CITY OF ALBUQUERQUE

**RE: Academy Dental Center
6421 Holly Ave NE
Revised Grading and Drainage Plan
Engineer's Stamp Date: 08/18/20
Hydrology File: C18D038A**

DRAINAGE AND TRANSPORTATION INFORMATION SHEET (REV 11-2018)

C2.0

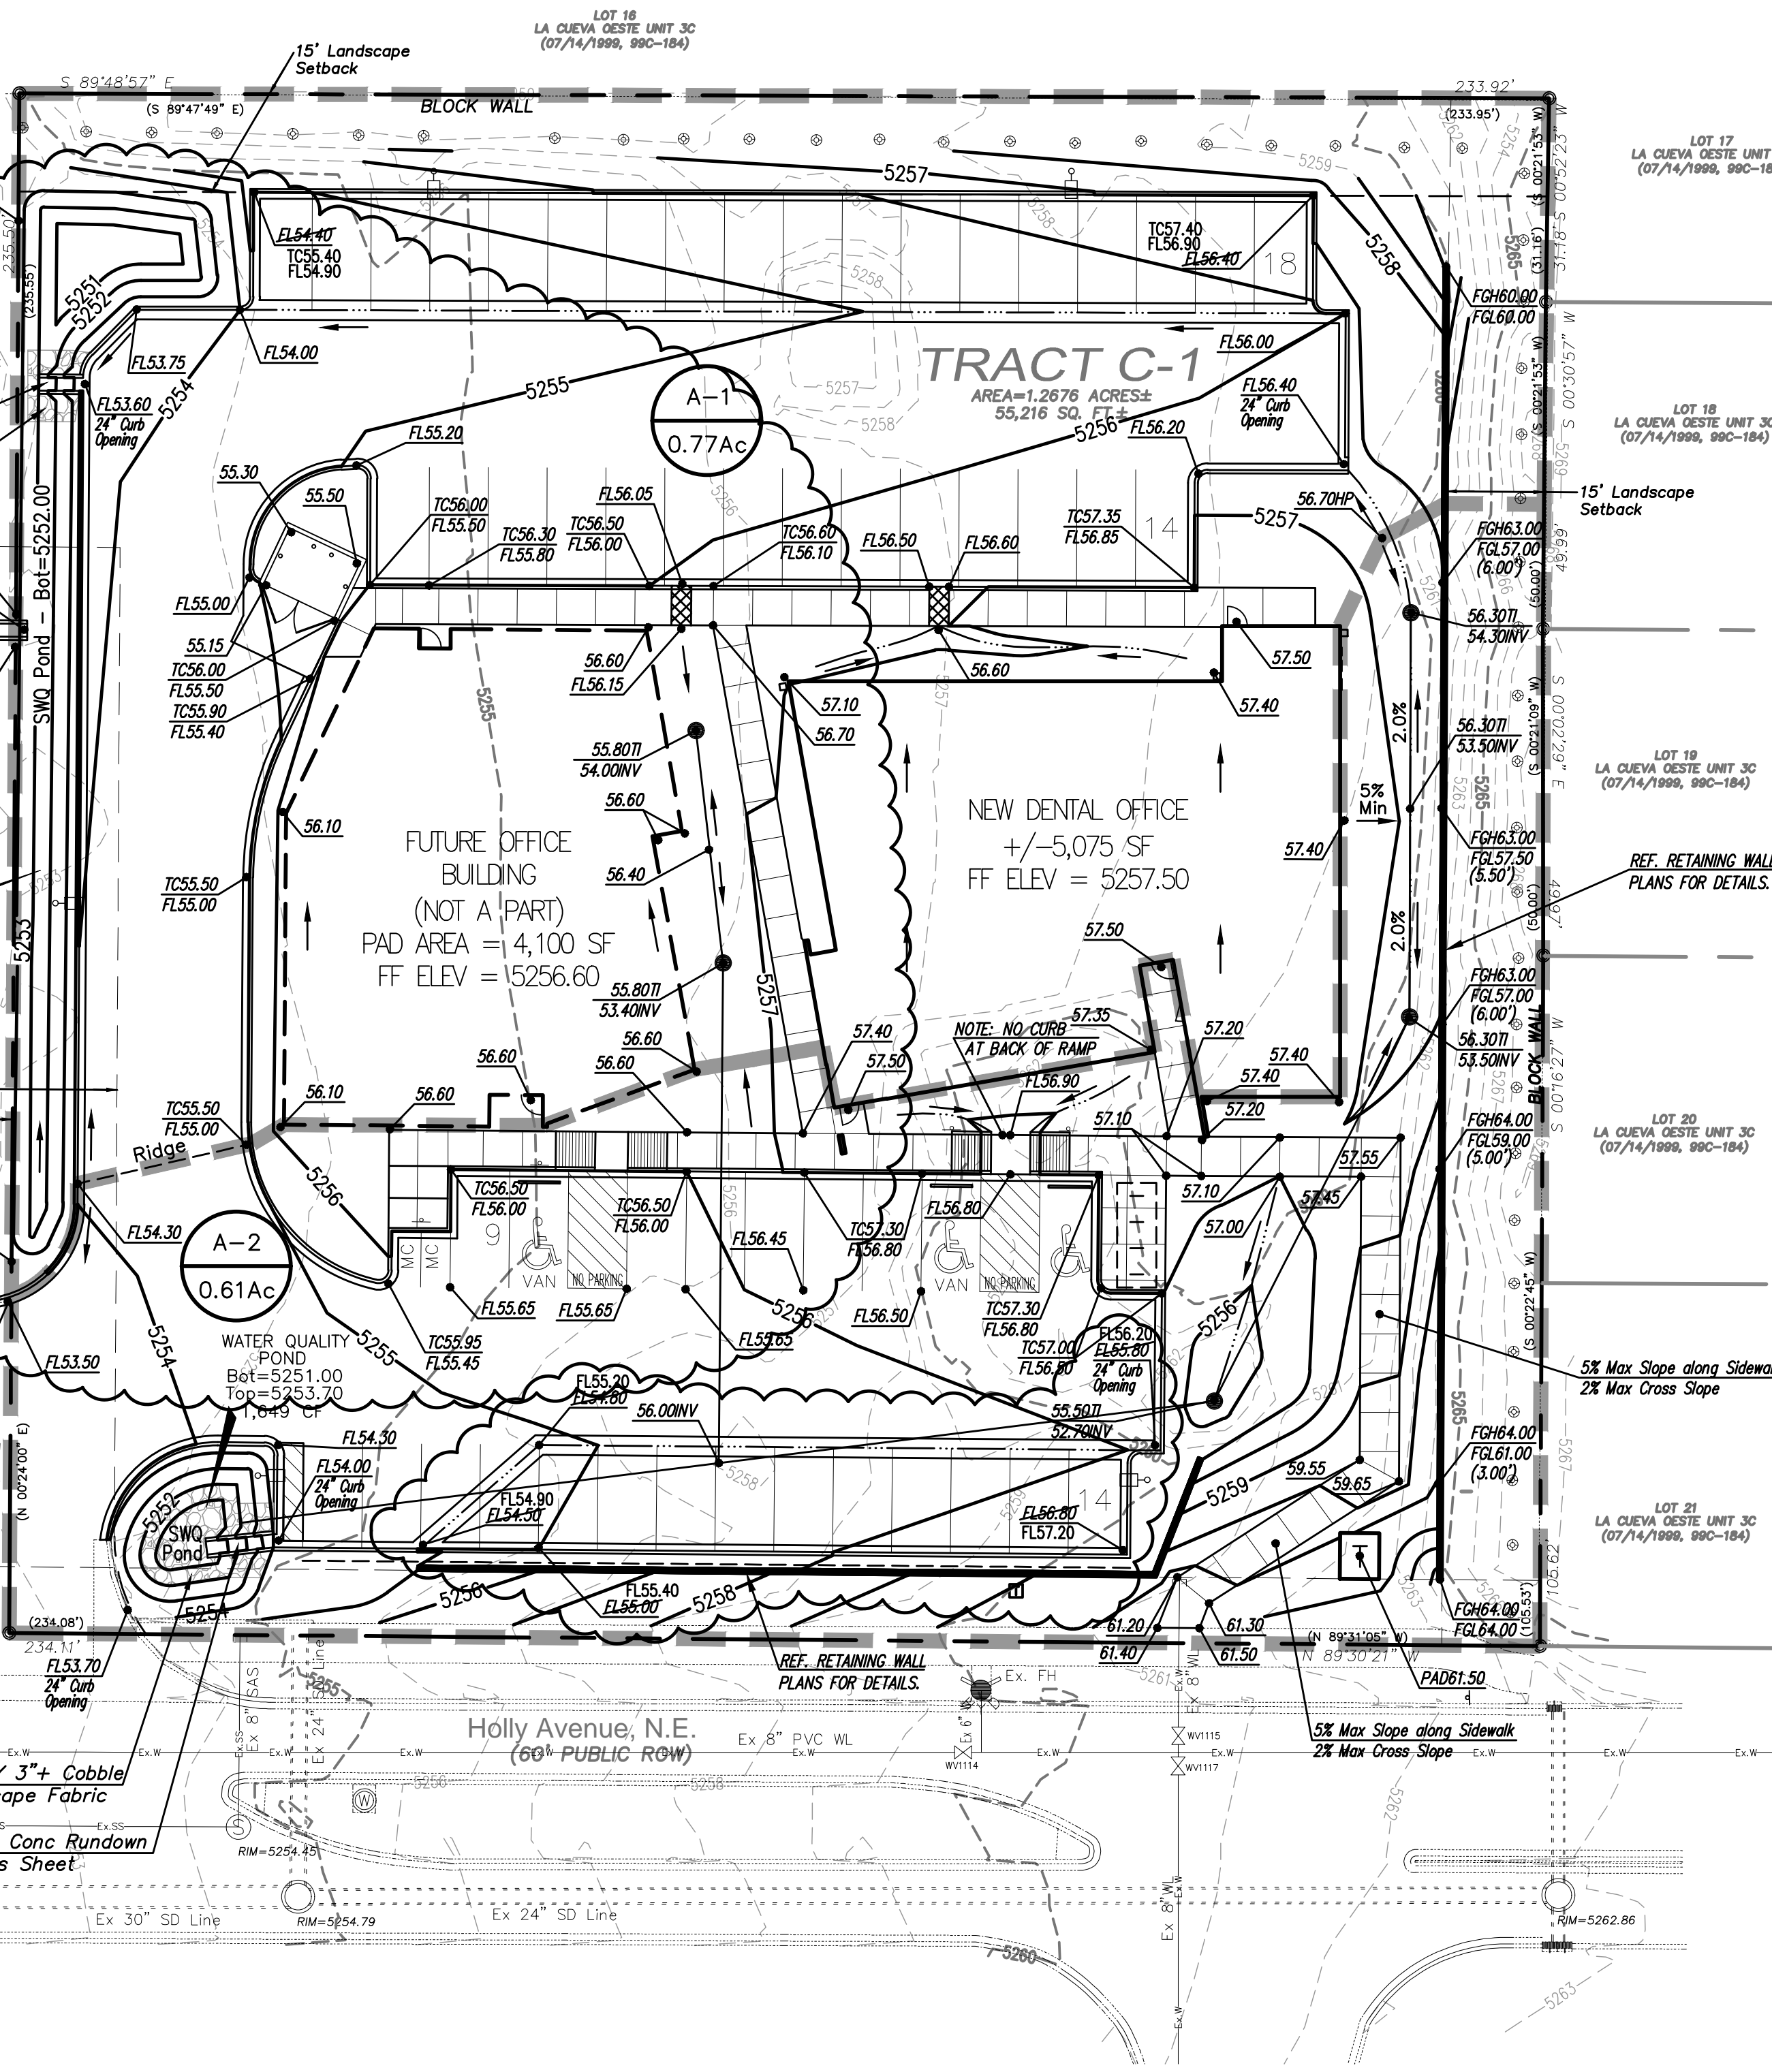
Based upon the information provided in your submittal received 08/18/2020, the Revised Grading and Drainage Plan is approved for Building Permit.

Please provide Drainage Covenant per Chapter 17 of the DPM prior to Permanent Release of Occupancy for the stormwater quality ponds. Please submit these to the 4th floor of Plaza de Sol. A \$25 fee for each will be required.
